FACILITY: Farley 2

SUBJECT: SUMMARY OF OCTOBER 22, 1980 MEETING REGARDING OPERATING LICENSE
REVIEW

REVIEW OF ALABAMA POWER COMPANY
AUXILIARY FEEDWATER SYSTEM
CONTROL AND PROTECTION LOGIC

Auxiliary Feedwater System
 Farley 1
 Figure 1

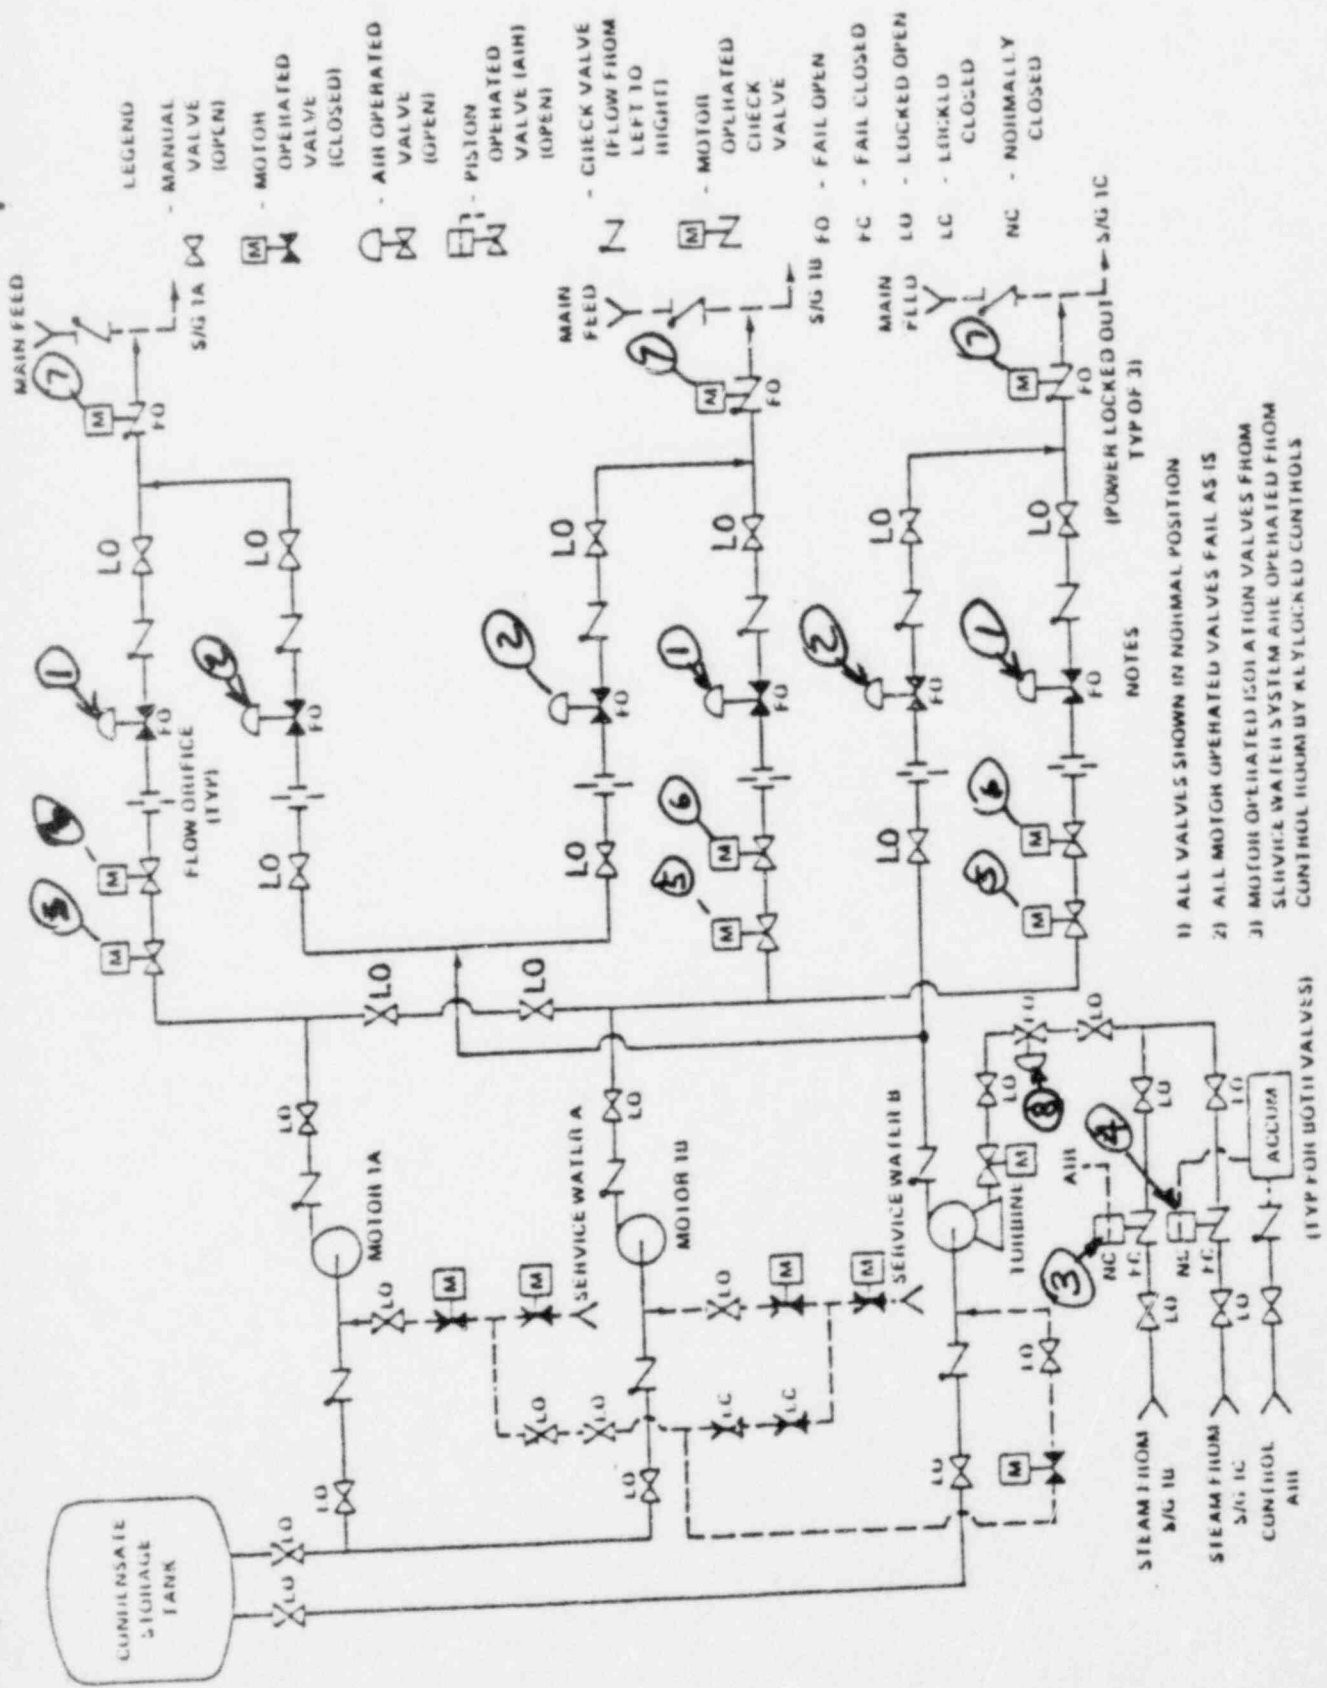
As indicated above, the current protection system logic is such that the motor driven auxiliary feedwater pump flow control valves are not automatically fully opened following a low low steam generator level signal, a signal indicating trip of the main feedwater pumps, or a blackout sequence signal if the valve operating mode switches are in the "modulate" position. In discussions of this feature, the applicant argued that administrative controls are adequate to ensure that the valves are left open during plant operation above 10% power or to ensure that valve operating mode switches are placed in the closed position such that the valves will automatically be opened. He also noted that administrative controls are relied on to ensure that other valves in the system are correctly positioned. For example, valves 5, 6, and 7 in Figure 1 are all remotely operated from the control room and must be in the open position for

Our position was that the logic and failure modes of the solenoid valves should be modified such that the loss of a single power supply will not cause the control valves to fail open.

The steam admission valves for the turbine driven AFW pump shown in Fig 1 are air controlled. Valves 3 & 4 require air to open and valve 8 is air to close. As previously noted, the electrical controls for these valves are powered from a battery/inverter supply which is independent from both the Train A and Train B power sources. The instrument air system is not safety grade. Since valves 3 & 4, require air to open, these valves have safety grade accumulators which are isolated from the normal non-safety grade air supply by two check valves in series (only one is shown in Figure 1). The

The use of two series check valves to isolate the turbine driven pump steam admission valve accumulators from the normal air supply differs from the Unit 1 design. The Unit 1 design utilizes a check valve and a solenoid operated valve, which closes by action of a pressure switch on low pressure, for the isolation. There is presently no way to independently verify by testing the operability of each check valve in the Unit 2 design. The advantage of the Unit 1 design, i.e., diversity and the fact that it is easier to verify its operability by testing, appears to make it a more reliable system for performing the required safety function. Our position was that the design for the isolation function should be the same for both units. We also requested information on the design basis for the isolation system to address a rapid and a slow depressurization of the normal air system as well as the method of independently testing the redundant means for isolating the accumulators from the normal air supply. We requested that the concerns contained in IE Bulletin No. 80-01 related to the check valve seat material also be addressed.

Fig. 2 Auxiliary Feedwater Pump Discharge Valve Control Scheme

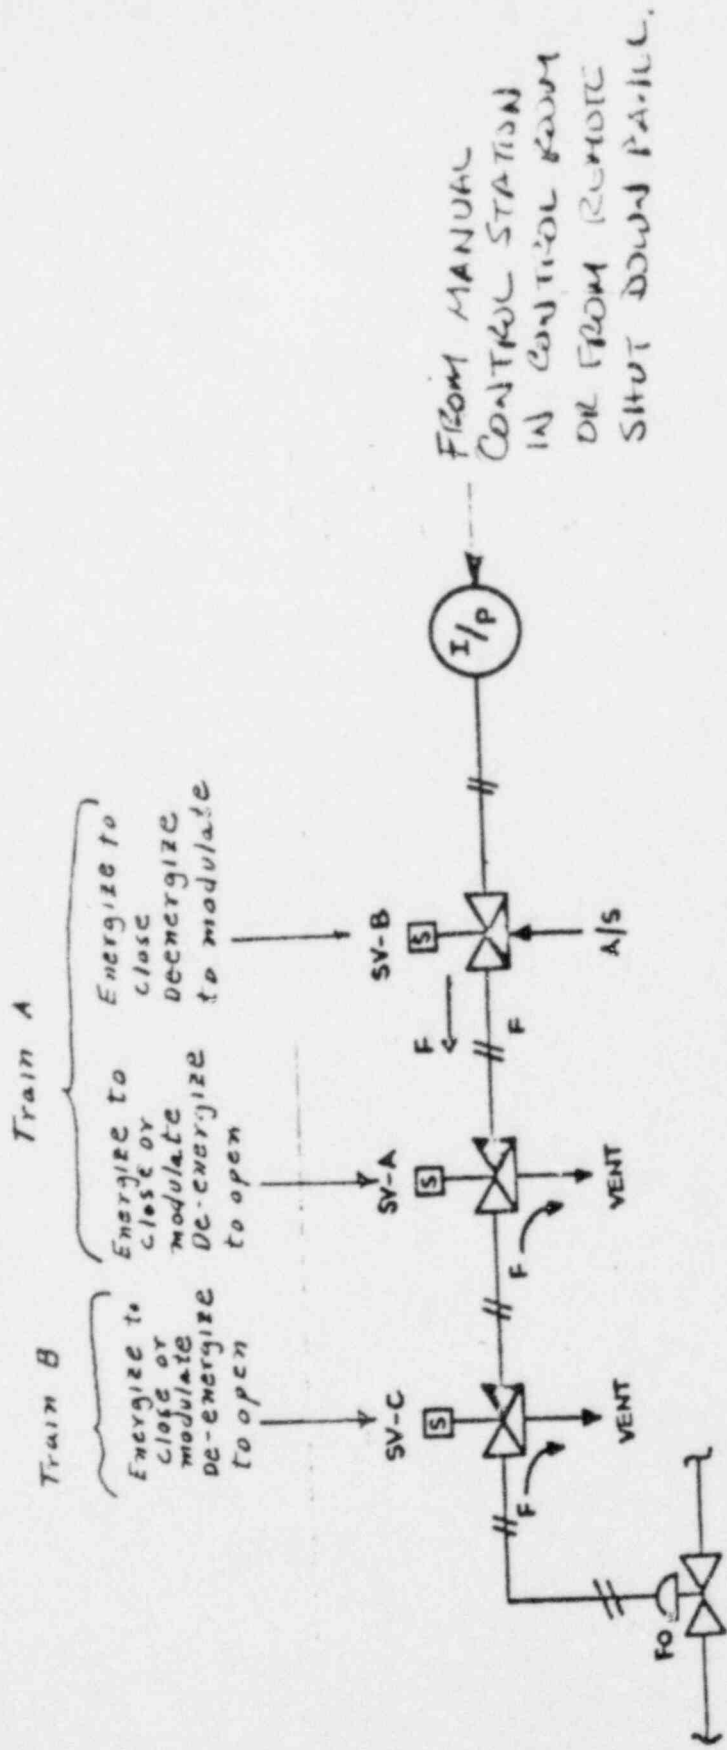
The control scheme for the flow control valves is shown in Figure 2. Redundant solenoid valves SV-A and SV-C are used to open the flow control valves on AFW initiation. They are presently arranged to "de-energize to open" the valves. On AFW initiation, the removal of power to either pilot solenoid valve causes the flow control valve to open. When the AFW system is in use, the loss of a single train power source would open all of the AFW flow control valves

resulting in full auxiliary feedwater flow to the steam generators. Manual control of the control valves from the control room would be precluded under these conditions.

The manual control stations for all of the AFW control valves are presently powered from a single train power source. Loss of this power source causes the valves to fail open and a loss of the capability to modulate AFW flow using any of the control valves. Our position was that the power distribution should be modified such that the manual control stations associated with the turbine driven AFW pump are powered from the power source used for the turbine driven pump steam admission valves and related controls. This power is derived from a battery/inverter which is independent of the Train A and Train B supplies. This would ensure that the loss of a single power source would not eliminate the
